Access Compliance Report Public Rights-of-Way (Pedestrian Signals)

Main Street: **KELLOGG_DR** Cross Street: **MOUNTAIN_VIEW_AVE** Location: **S**

ADA ID: **SGAT210922121351** Signal Type: **One Push Button-Non APS** Overall Compliance: **No** Severity Scores: **BTN 1: 35** **BTN 2: N/A** **No BTN: N/A**

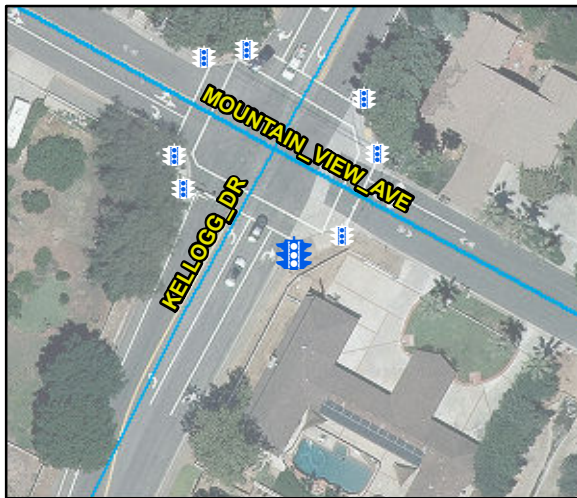
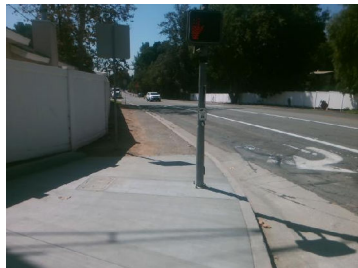
OC Std/PROW: **MUTCD 4e.08, R404.2**

Possible Solutions: Replace Signal Push Button With APS Button. Remove & Relocate Sign.
